INSTALLATION INSTRUCTIONS

Landmark - Add Spacer Washer to Sanitary Ice Lever Switch

FIGURE 1 Side view of ice dispense switch assembly

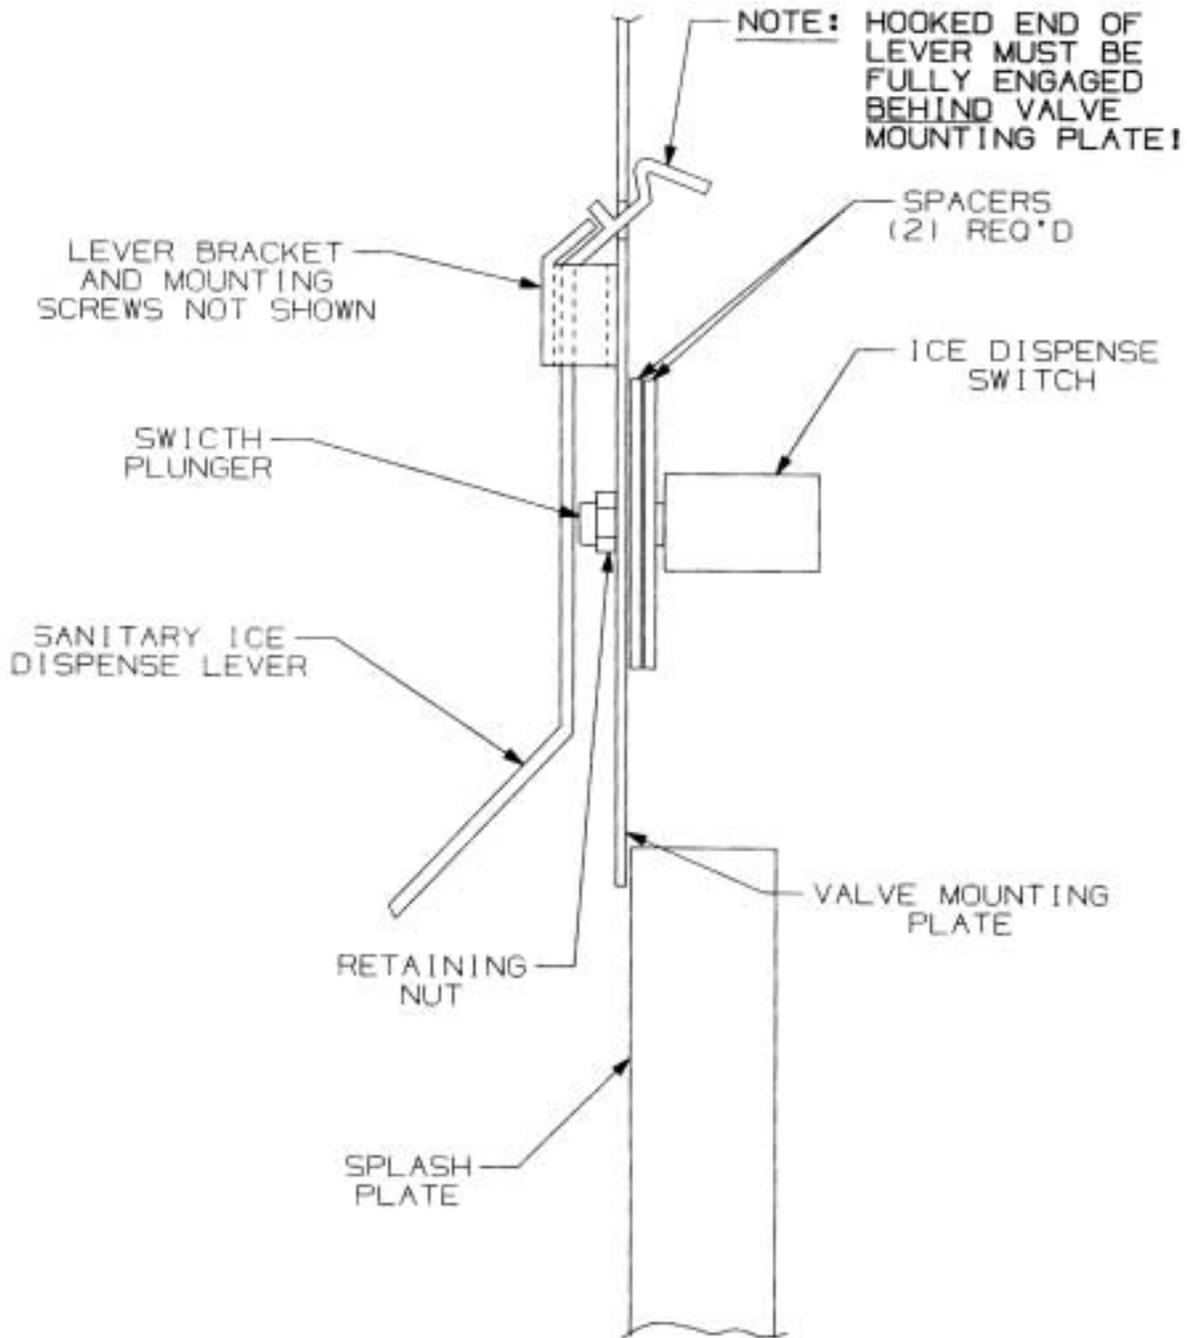
There should be two (2) washers backing up the sanitary ice lever switch to properly position the switch. *Landmarks* shipped prior to April 28, 1996, contained one (1) washer. The following instructions show how to add a second washer. Please refer to the accompanying figure for greater detail.

1. Remove the two screws and metal bracket holding the ice dispensing lever. Note how the lever is installed in the slot on the valve mounting plate so it can be reinstalled correctly after the spacer is replaced. Remove the ice dispense lever.
2. With a 7/16-inch wrench, loosen the nut on the switch plunger.
3. Slide the switch out, being careful not to lose the existing spacer washer.
4. Place the additional spacer washer, supplied with the kit, on the shaft with the other spacer washer. A total of two (2) washers should be installed on switch when completed. Two washers are supplied in the washer kit if both are needed.
5. Replace the switch and retaining nut previously removed.
6. Install the lever, placing the top of the lever in the slot on the valve mounting plate.

NOTE: Hooked end of lever must be fully engaged behind valve mounting plate! Otherwise switch plunger may jam in "ON" position. Replace the lever bracket and two screws.
